HILL EAST PARCELS B1 + B2

WASHINGTON, DC
GTM ARCHITECTS DC PROJECT #21.0515

ZONING COMMISSION
District of Columbia
CASE NO. 24-008
EXHIBIT NO. 2A3

PARKING LEVEL 2 | A1.01

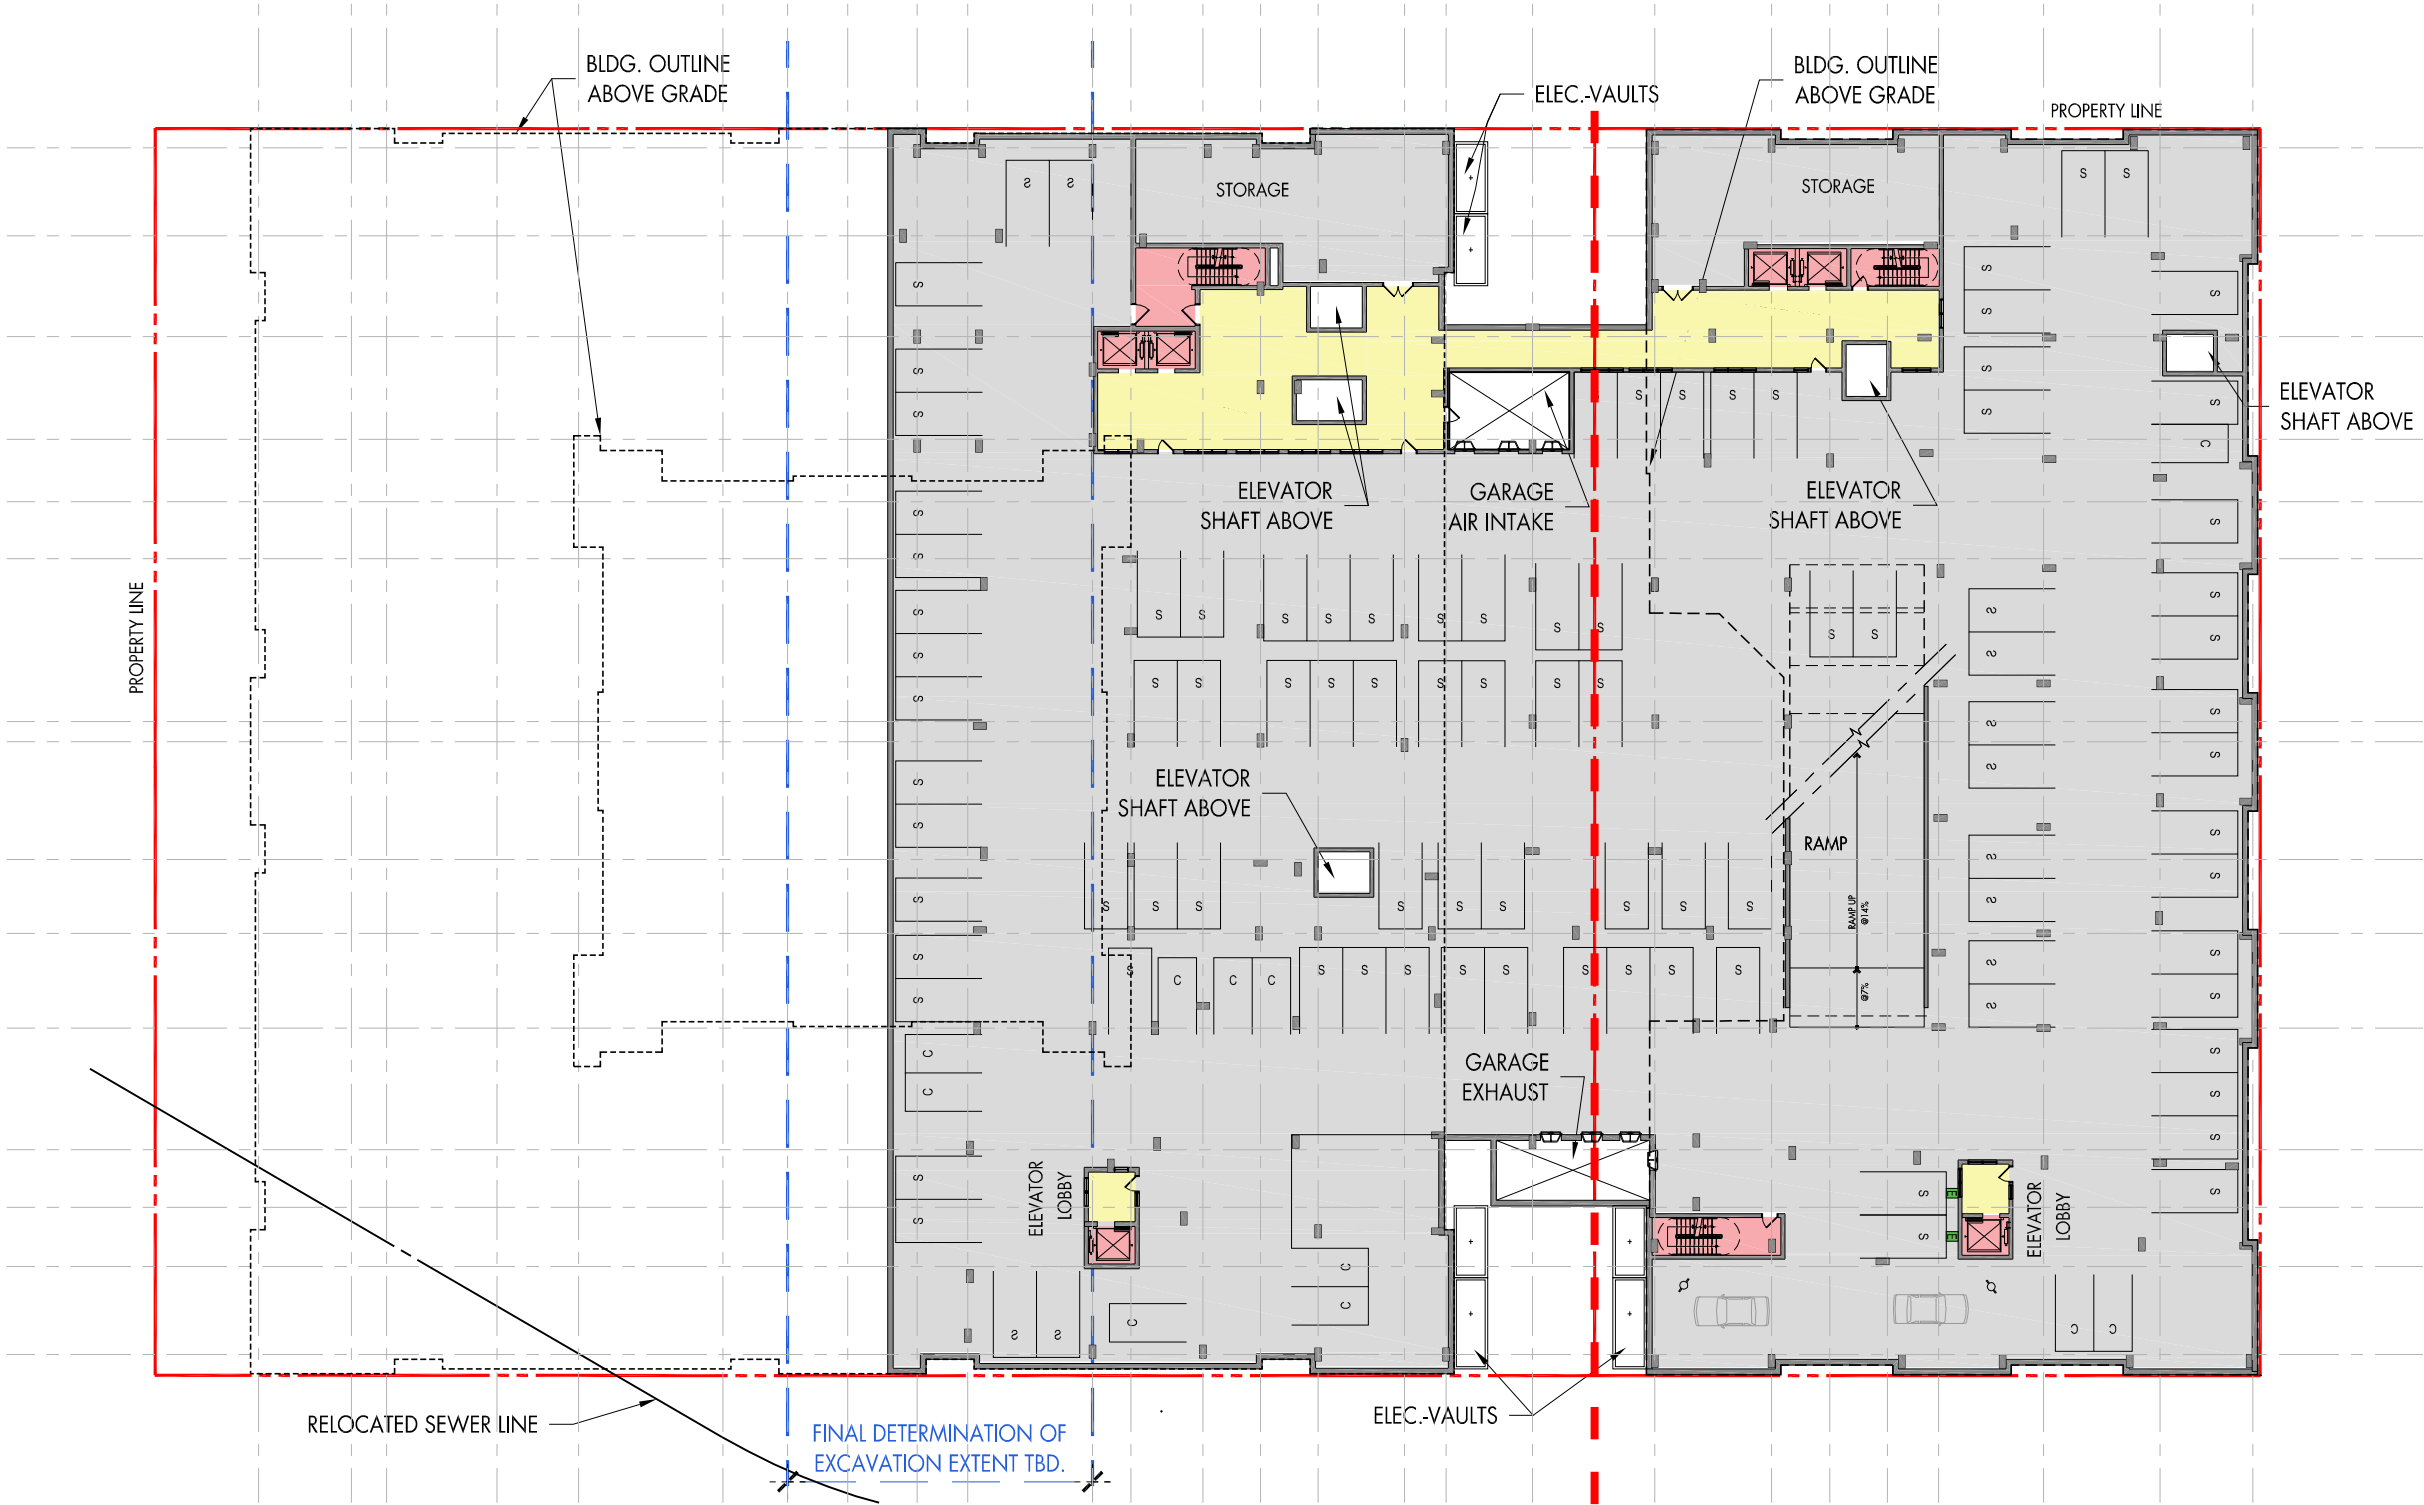
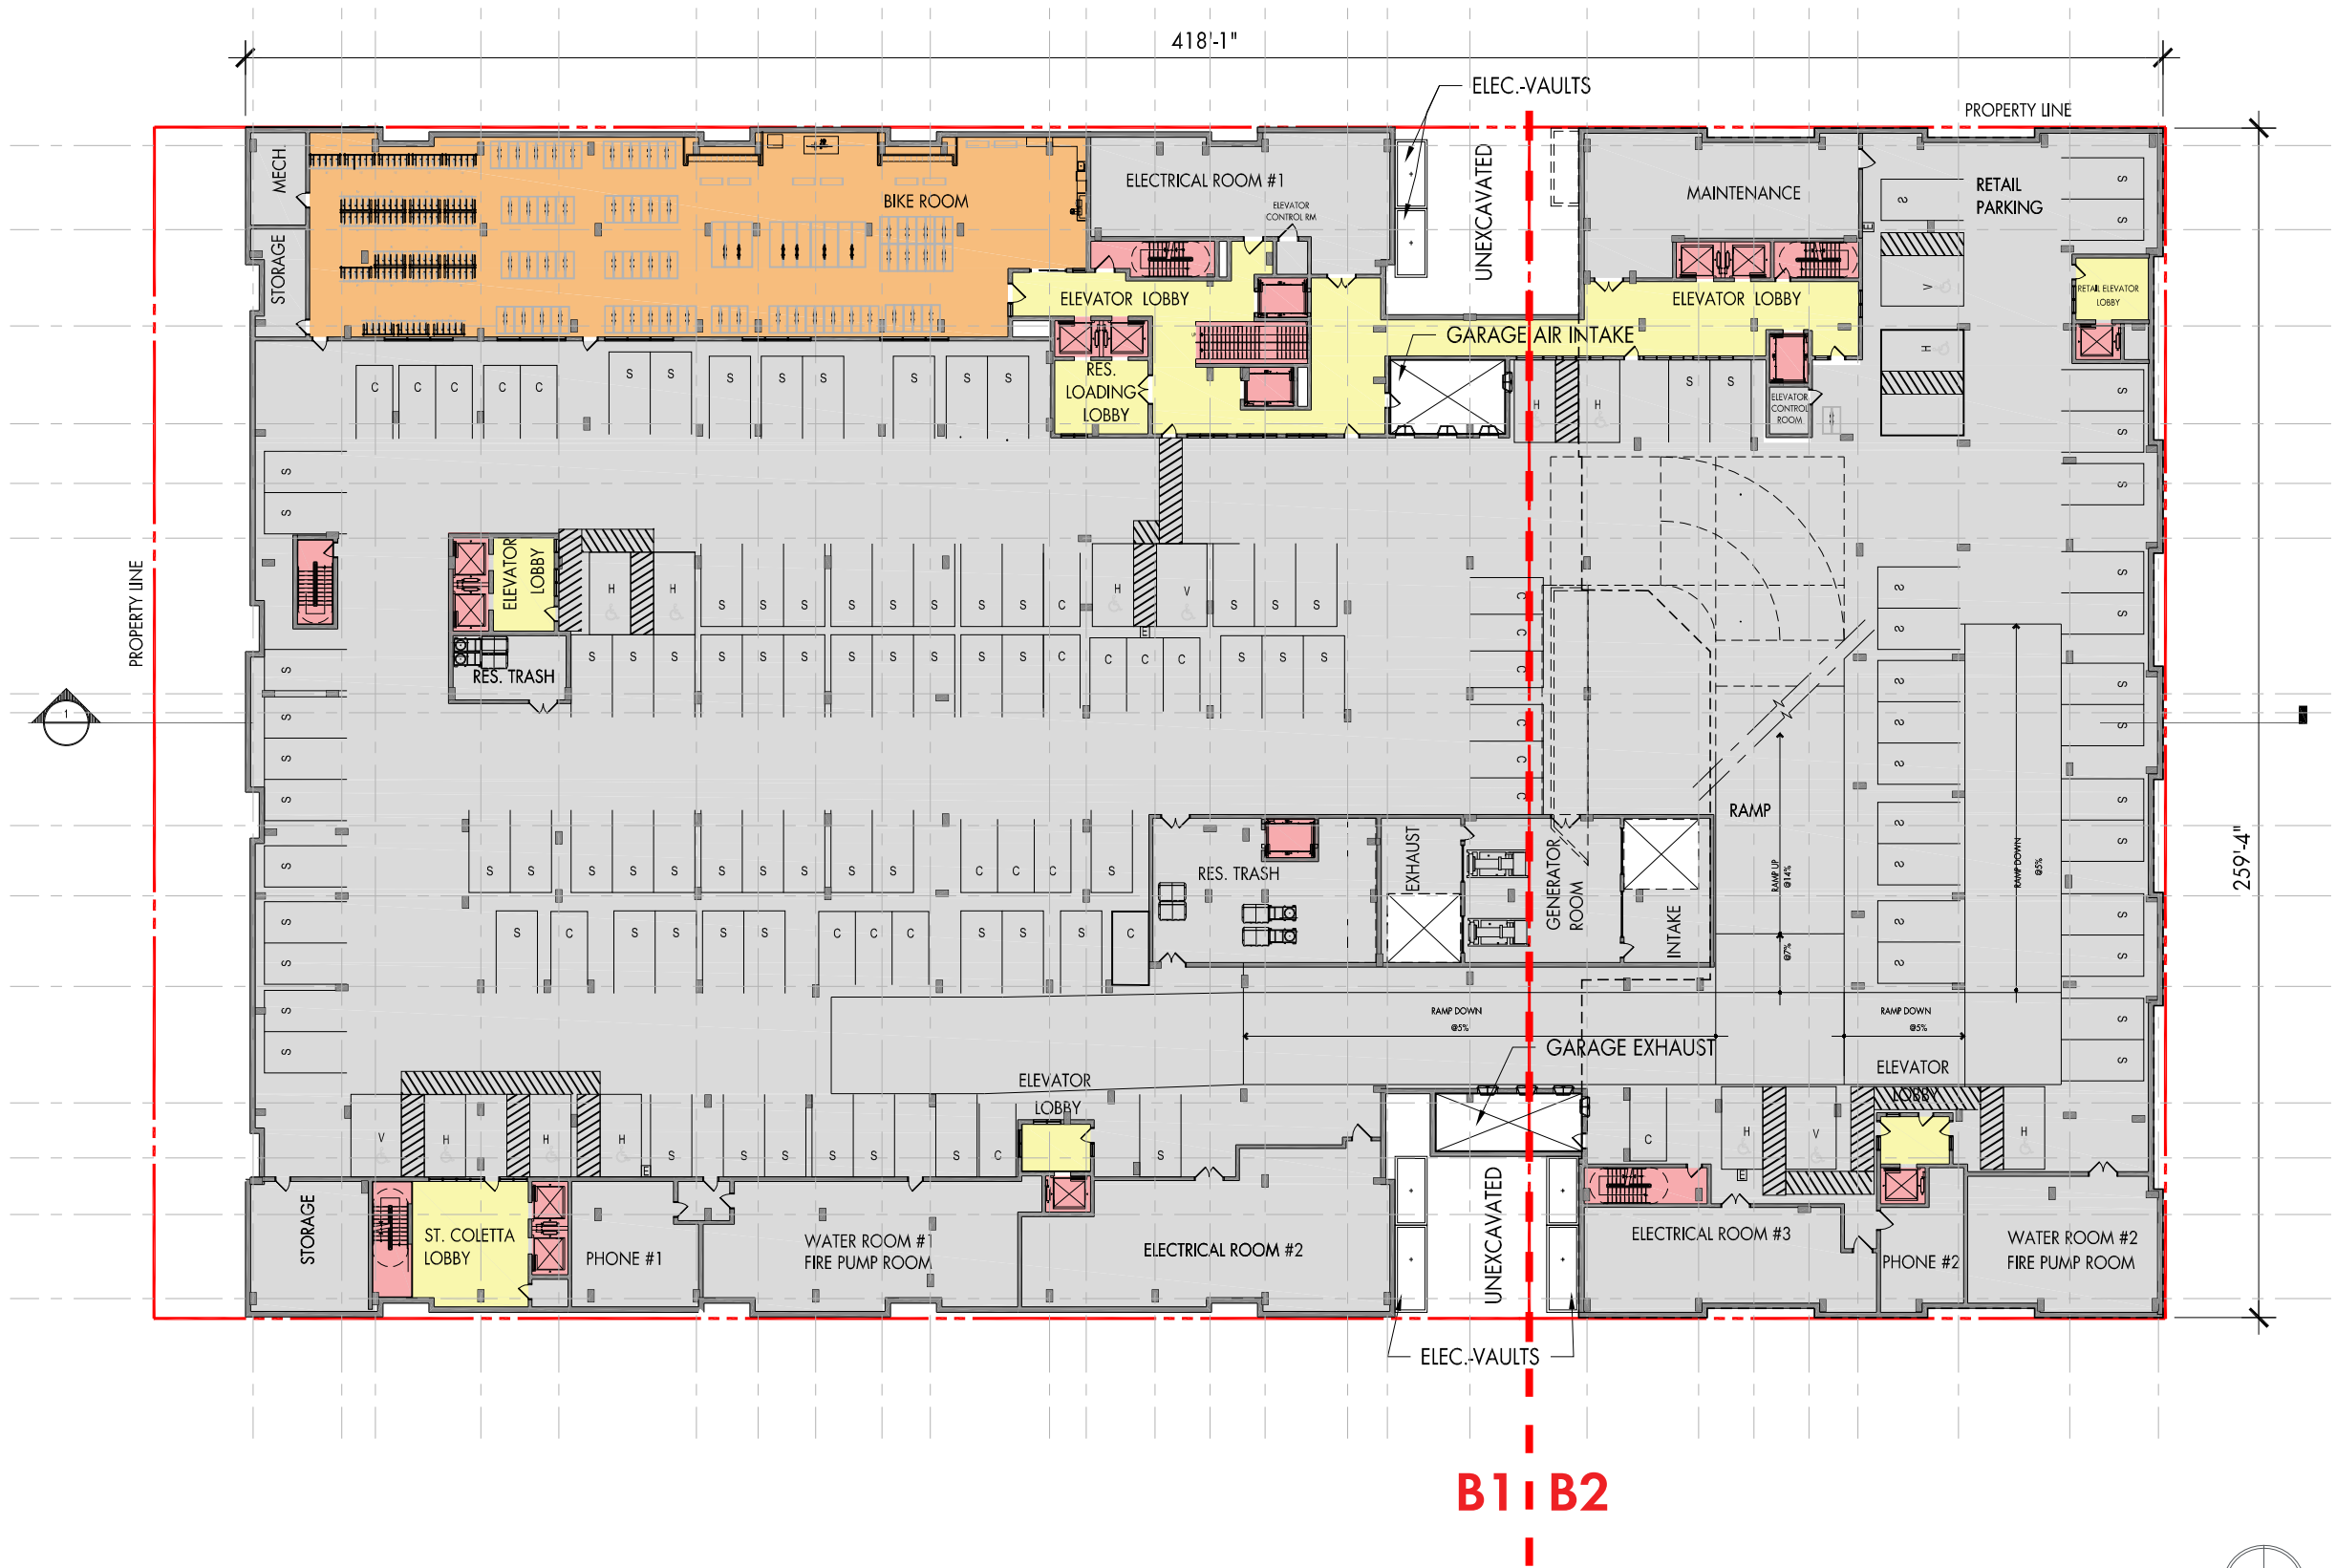
AREA OF MODIFICATION

NOTE:
VEHICLE AND BIKE PARKING REDUCED IN
BUILDING B2 DUE TO DELETION OF RETAIL AND
REDUCED UNIT COUNT.
